Re: **Raw Cider Company (PWS #[95737](#))**  
**2022 Well #1 ([L149426](#), [YAMH59117](#))**  
**Conditional Approval ([PR #45-2024](#))**

**Based upon the submitted information, the project is granted Conditional Approval, which means that for Final Approval, the following conditions will need to be met:**

Approximate 100-ft and 500-ft radii around the wellhead:

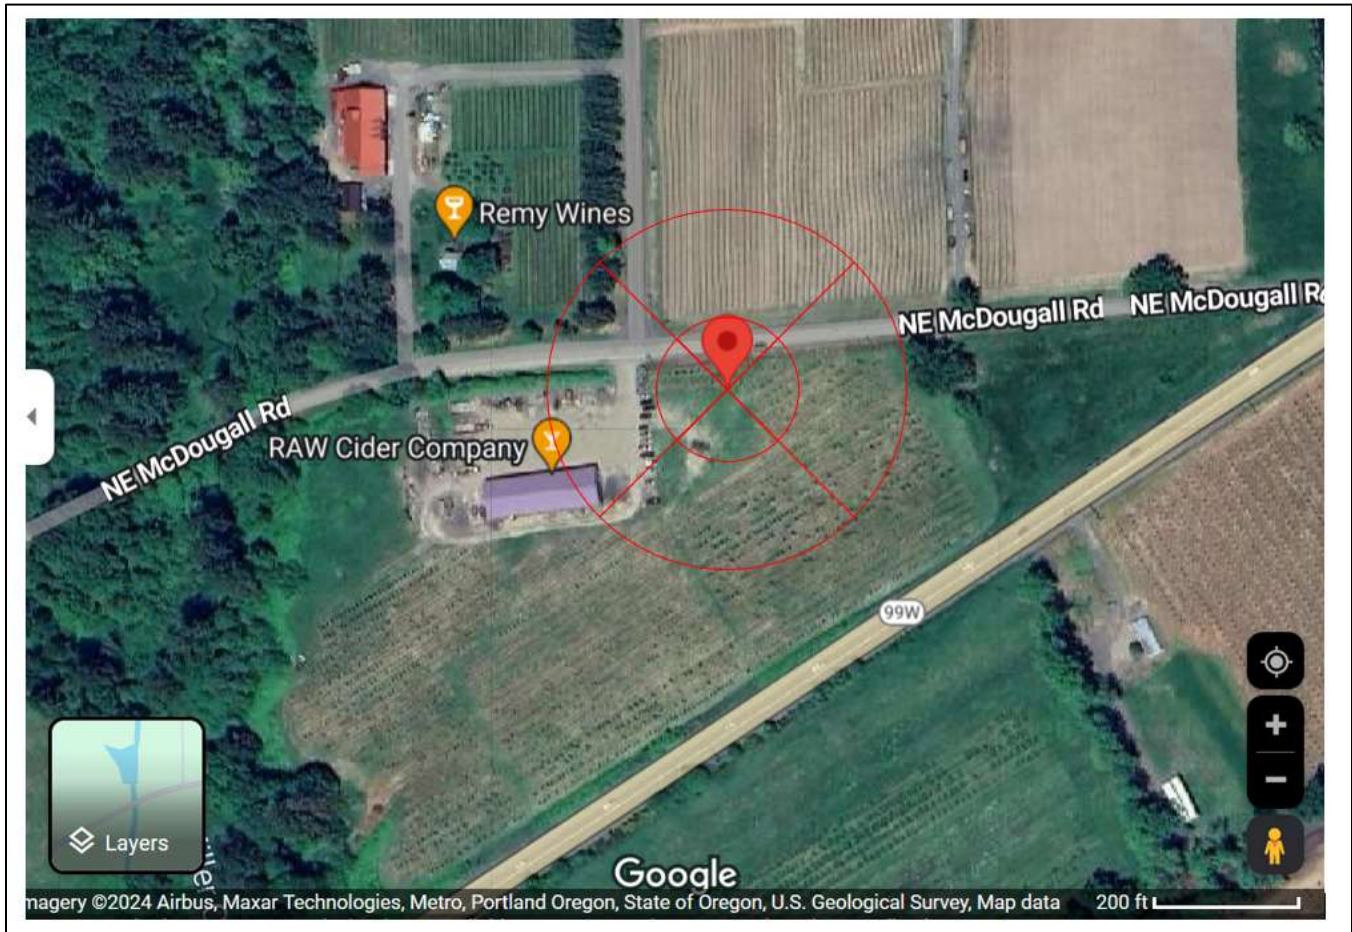
**Please complete this waiver form** and email it back to me at [evan.e.hofeld@oha.oregon.gov](mailto:evan.e.hofeld@oha.oregon.gov). You may indicate that you are seeking a waiver from [OAR 333-061-0050\(2\)\(a\)\(D\)](#) due to the presence of NE McDougall Rd being roughly 50-ft north of the 2022 well ([L149426](#)) as shown in the map below, which was found by Tom Pattee (per the well evaluation report completed under PR #45-2024) to be adequately constructed into a deep confined layer basalt aquifer and therefore, both the well and the aquifer have a low susceptibility to activities associated with the road.

Hydrogeologists comments regarding request for Waiver from Construction Standards: A roadway is present within the 100 ft sanitary setback. The well is adequately constructed to draw water from a deep confined layered basalt aquifer. Furthermore, Sensitivity Analysis results suggest that water quality from this drinking water source has a low susceptibility to activities associated with the roadway that occurs within the 100 ft sanitary setback.

well head and Septic are 380 ft apart in the diagram below.  
NE McDougall Rd is approximately 50-ft north of the well.

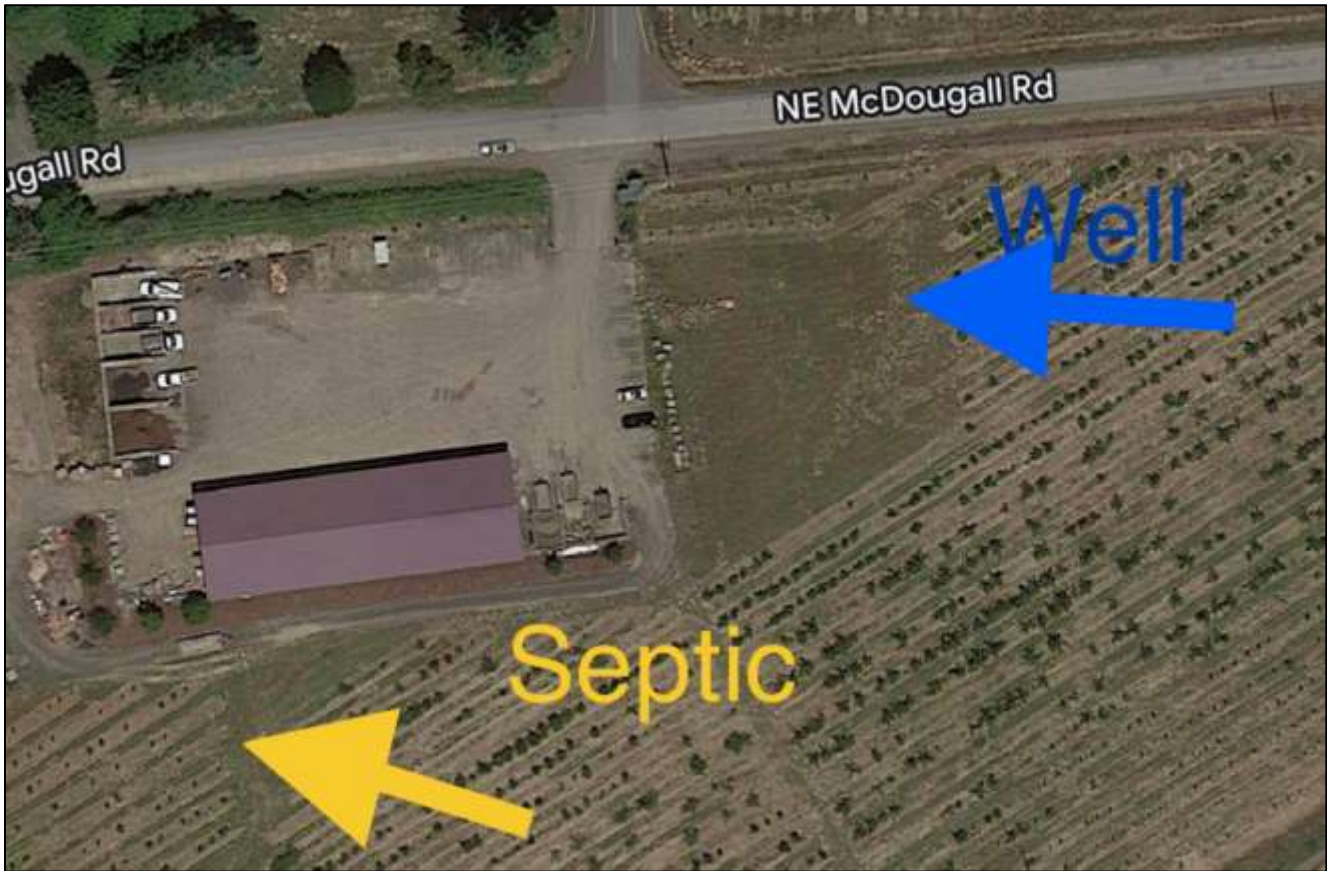
2. **Public or private roadways may be allowed within 100 feet of a confined well, provided the well is protected against contamination** from surface runoff or hazardous liquids which may be spilled on the roadway and is protected from unauthorized access.

3. **The following sanitary hazards are not allowed within 100 feet of a well** which serves a public water system unless waived by the Authority: any existing or proposed pit privy, subsurface sewage disposal drain field; cesspool; solid waste disposal site; pressure sewer line; buried fuel storage tank; animal yard, feedlot or animal waste storage; untreated storm water or gray water disposal; chemical (including solvents, pesticides and fertilizers) storage, usage or application; fuel transfer or storage; mineral resource extraction, vehicle or machinery maintenance or long term storage; junk/auto/scrap yard; cemetery; unapproved well; well that has not been properly abandoned or of unknown or suspect construction; source of pathogenic organisms or any other similar public health hazards. No gravity sewer line or septic tank shall be permitted within 50 feet of a well which serves a public water system. Clearances greater than indicated above shall be provided when it is determined by the Authority that the aquifer sensitivity and degree of hazard require a greater degree of protection. Above-ground fuel storage tanks provided for emergency water pumping equipment may be exempted from this requirement by the Authority provided that a secondary containment system is in place that will accommodate 110 percent of the fuel tank storage.
